**HUMER KWER HEALTH CENTER
SULAYMANIYAH, IRAQ**

SUSTAINMENT ASSESSMENT

**SIGIR PA-09-186
APRIL 20, 2010**

SUBJECT: Report on the Humer Kwer Health Center Sulaymaniyah, Iraq
(SIGIR Report Number PA-09-186)

**Figure 1. Humer Kwer Health Center project site plan
(Courtesy of GRN)**

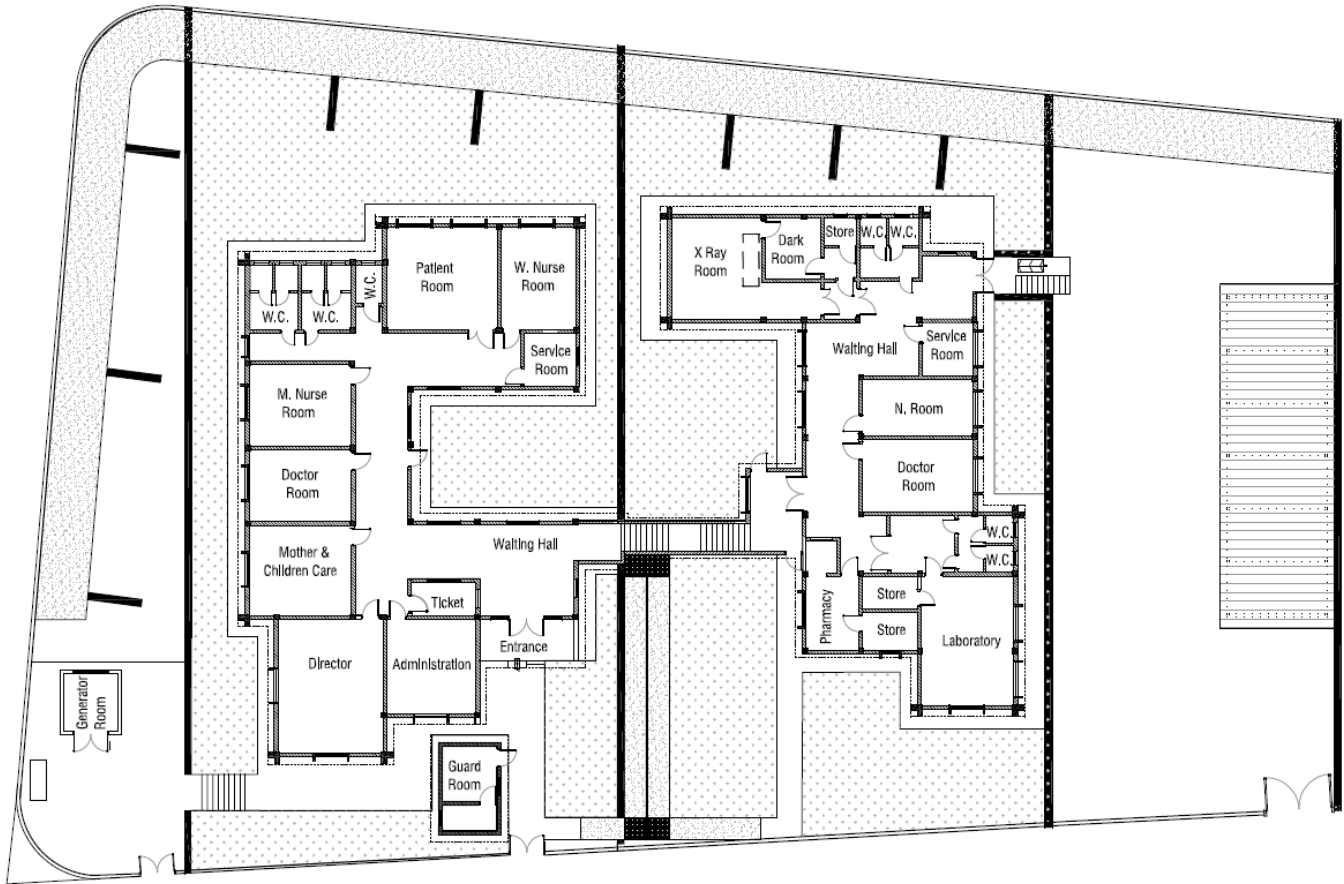
Actual construction plans differed from the conceptual site plan. The conceptual site plan was developed without the benefit of accurate topographic information for the project. Elevations shown on the conceptual site plan indicated a proposed level pad for the building and parking with only 0.20 meters of elevation change across the site. The contractor performed a topographic survey of the site to determine the actual site elevation differential. Based on the topographic survey, the actual differential in elevation across the site is approximately 18 meters. The contractor's site plan indicated the use of retaining walls to terrace the site. The building was shown on two separate levels with parking on a third level. The contractor's site plan shows the project construction within a 3,000 square meter area (Figure 1).

An exterior ramp is shown connecting the upper and lower levels of the building. The ramp is fairly long, and contains one intermediate landing. The design slope for the ramp is 10%. This is a difficult grade for handicapped individuals to traverse.

**Figure 2. Steel fence secured to retaining wall
(Courtesy of GRN)**

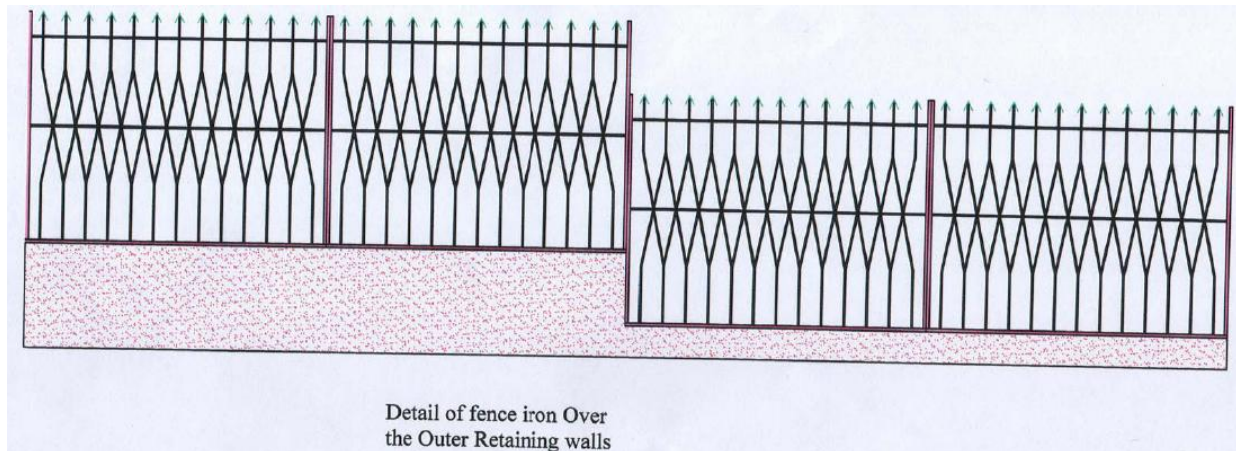
The perimeter security wall details provided with the conceptual design drawings included details for the concrete masonry unit⁴ (CMU) wall, foundation, and reinforcement for the gates and is identical on the contractor's drawings. In several areas the need for a retaining wall precludes the construction of a CMU security wall. In these areas, the contractor proposed a steel fence mounted to the top of the retaining wall (Figure 2).
